UNITED STATES PATENT AND TRADEMARK OFFICE

APPLICATION NO.	FILING DATE	FIRST NAMED INVENTOR	ATTORNEY DOCKET NO.	CONFIRMATION NO.
10/774,682	02/09/2004	Thomas Rueckes	112020.129 US2 (Nan-6)	9428
23483	7590	09/14/2005		
WILMER CUTLER PICKERING HALE AND DORR LLP 60 STATE STREET BOSTON, MA 02109			EXAMINER COLEMAN, WILLIAM D	
			ART UNIT 2823	PAPER NUMBER
DATE MAILED: 09/14/2005

Office Action Summary

DETAILED ACTION

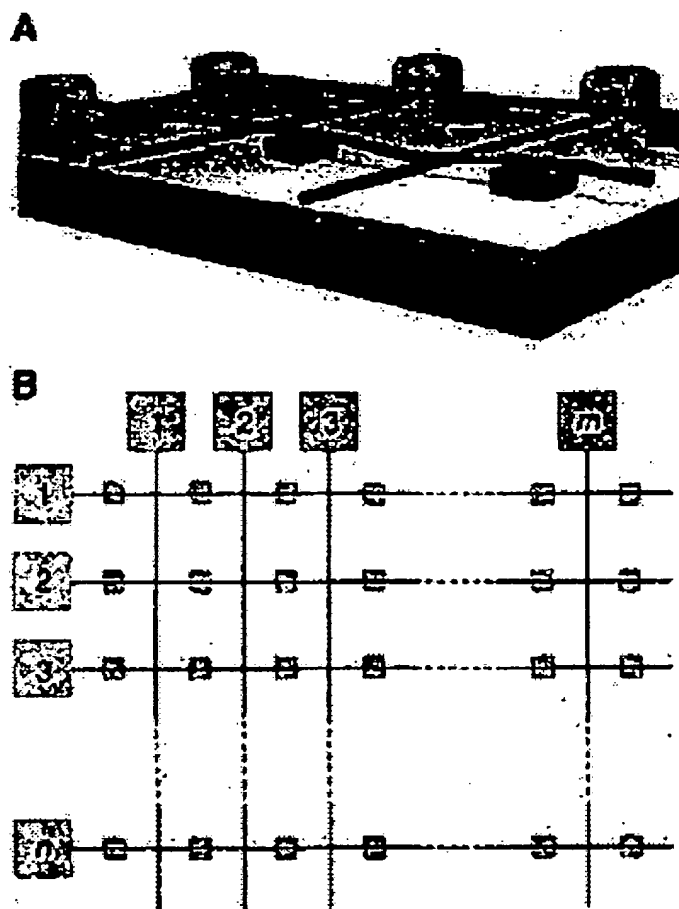
1. Pertaining to claim 1, Rueckes teaches an assembly including a substrate and a conductive trace disposed on the substrate, wherein the trace includes a plurality of unaligned nanotubes for providing a plurality of conductive pathways along the trace. Rueckes teaches a random distribution of metallic and semiconductor tubes, however Rueckes does not explicitly state that these tubes are a plurality of unaligned nanotubes. Kaneto teaches a plurality of unaligned nanotubes. See FIG. 1(a) and 1(b) of Kaneto where clusters of nanotubes are disclosed. In view of Naneto, it would have been obvious to one of ordinary skill in the art to recognize that carbon nanotubes are initially in the form of clusters because the electrical conductivities of individual nano tubes have been measured (see Abstract).

13. Pertaining to claim 13, Rueckes in view of Kaneto teaches a wafer substrate structure having a non-woven fabric of unaligned nanotubes covering a major surface of the wafer substrate and wherein the nanotubes of the fabric are arranged in accordance with inherent self-assembly traits of the nanotubes (see FIG. 1B).
